**IMAGINE**  
**SPRING GARDEN ROAD**

**MAKING A GREAT STREET EVEN BETTER**

# ACCESSIBILITY AUDIT

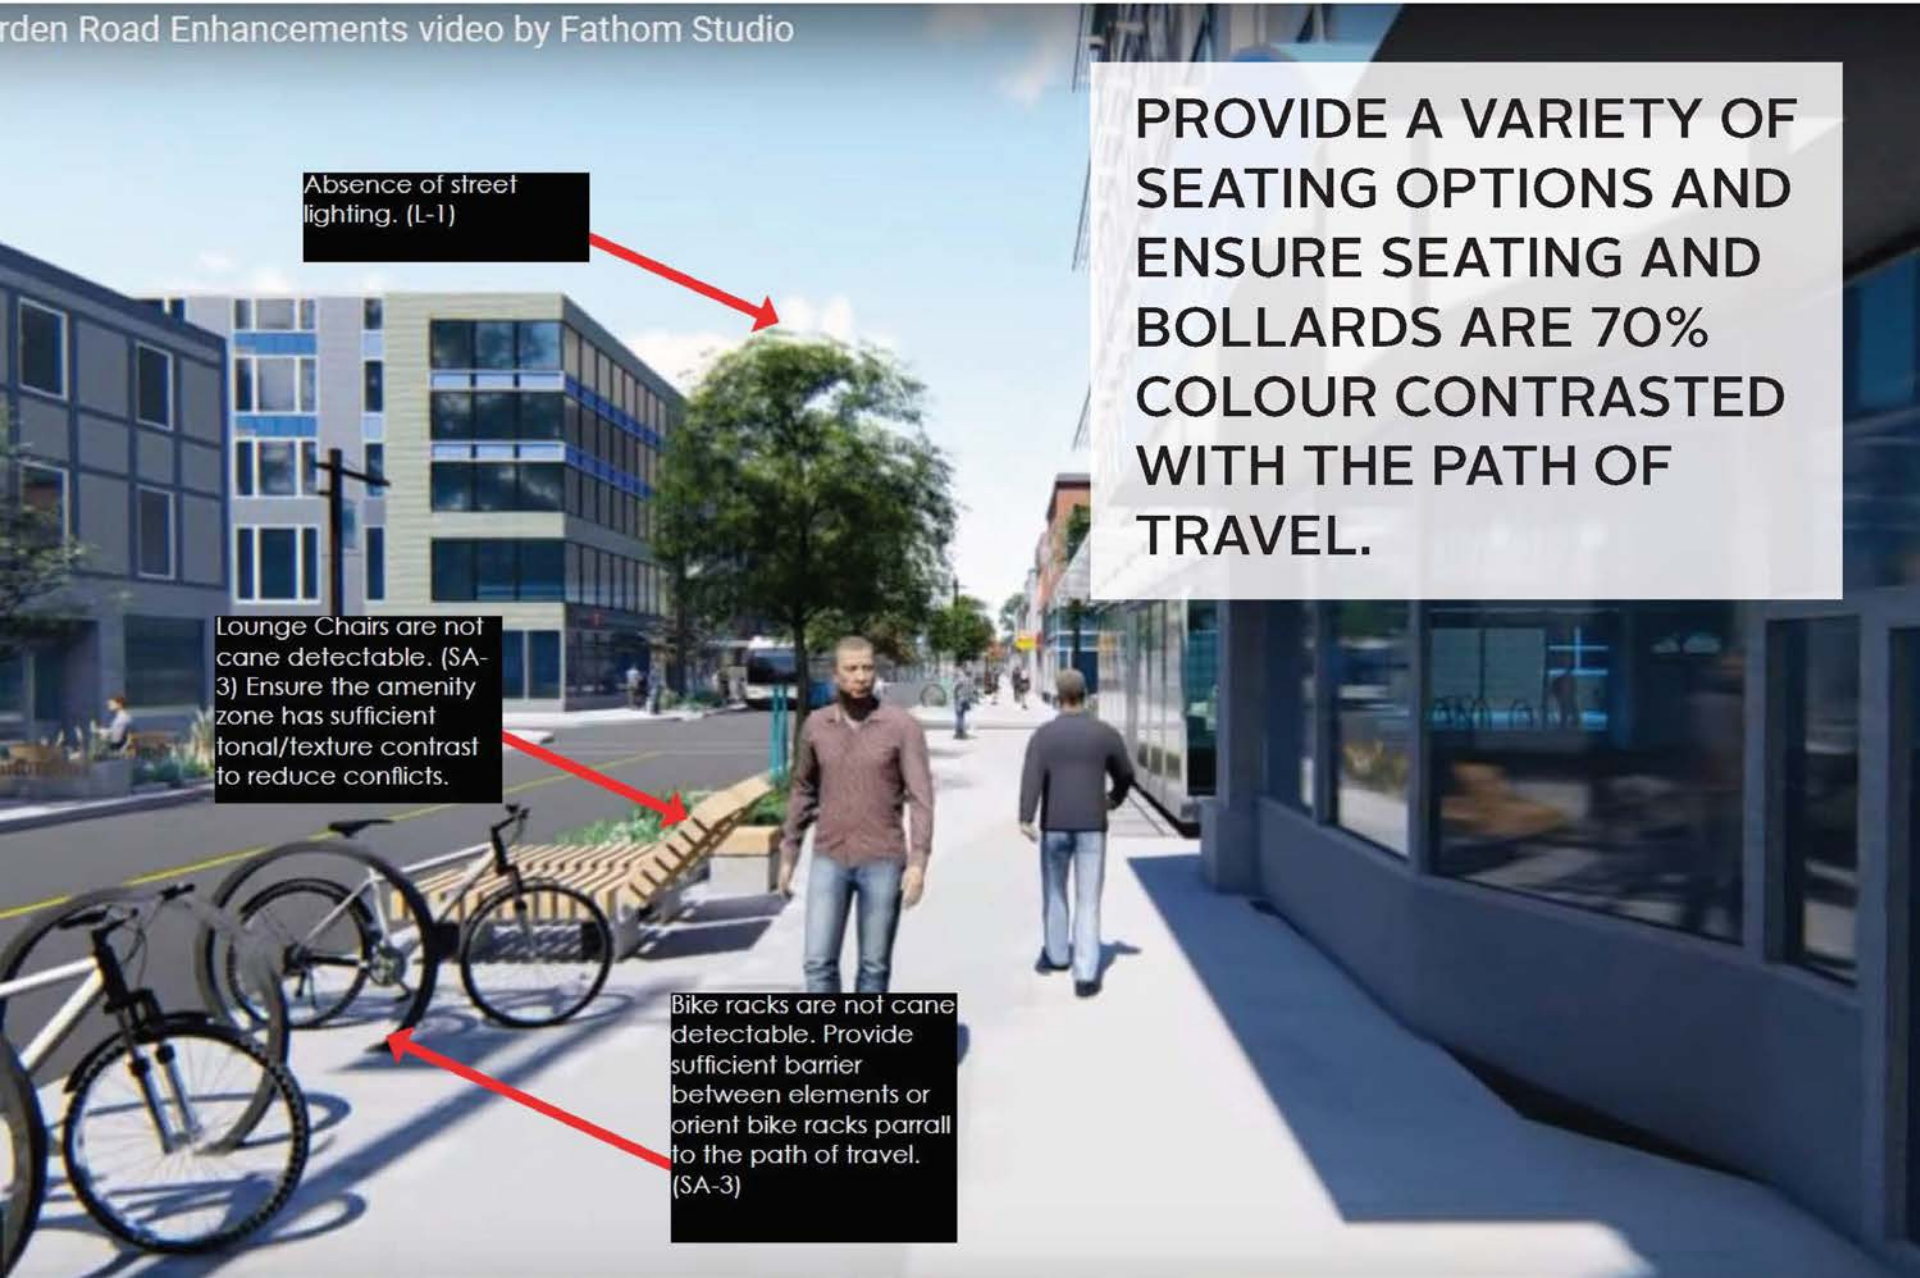
Transit Stops require directional TWSI's across entire path of travel. (TS-2)
